Access Compliance Report

Public Rights-of-Way

(Curb Ramps)

Intersection ID: 48792	Main Street: WOODLAND_WATCH_CT	Cross Street: COMMUNITY_HOUSE_RD	Location: NE
ADA ID: C76B615C32BE	Ramp Type: PerpDiag	Initial Pass/Fail: Fail	Overall Compliance: No
Severity Score: 12.5			
Codes/Mitigation Info/Possible Solution		Field Measurements/Component Compliance

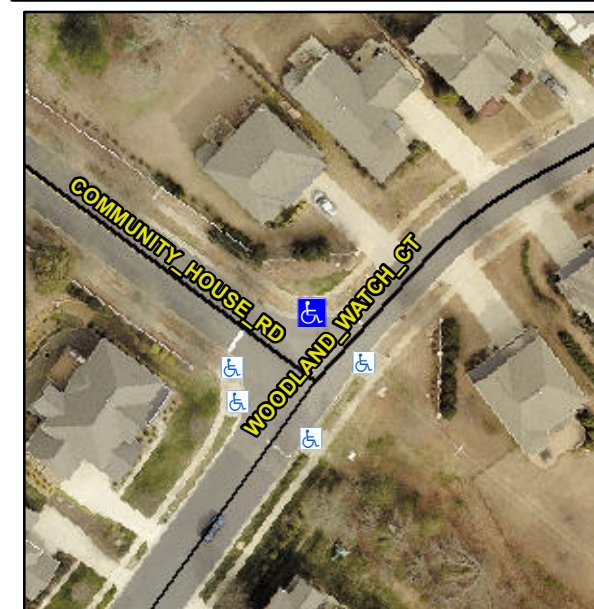
Not Found, R304.2.2

Compliance	Description	Data	Compliance	Description	Data
N/A	Ramp Length (in)	72.0	No	Ramp Slope (%)	9.1
Yes	Ramp Width (in)	53.0	Yes	Ramp XSlope (%)	0.8
N/A	Flare Type LT	N/A	N/A	Flare Type RT	N/A
N/A	Flare Slope LT (%)	N/A	N/A	Flare Slope RT (%)	N/A
N/A	Flare Traversable LT?	N/A	N/A	Flare Traversable RT?	N/A
N/A	Landing Length (in)	N/A	N/A	DWS Provided?	N/A
N/A	Landing Width (in)	N/A	N/A	DWS Contrast?	N/A
N/A	Landing Slope (%)	N/A	N/A	DWS Length (in)	N/A
N/A	Landing X Slope (%)	N/A	N/A	DWS Full Width?	N/A
N/A	Landing Curb? (Y/N)	N/A	N/A	DWS Offset (in)	N/A
N/A	Shared Landing?	N/A			
N/A	Gutter Ponding?	N/A	N/A	Gutter Slope (%)	N/A
N/A	Gutter Lip Ht (in)	N/A	N/A	Gutter X Slope (%)	N/A
N/A	Painted X Walk1?	No	N/A	Painted X Walk2?	No
	X Walk 1 Direction	To SW		X Walk 2 Direction	To SE
N/A	X Walk 1 Width (in)	N/A	N/A	X Walk 2 Width (in)	N/A
	X Walk 1 Slope (%)	0.3		X Walk 2 Slope (%)	0.6
	X Walk 1 X Slope (%)	0.6		X Walk 2 X Slope (%)	1.0

Remove & Replace Curb Ramp With Two New Directional Ramps or Equivalent.
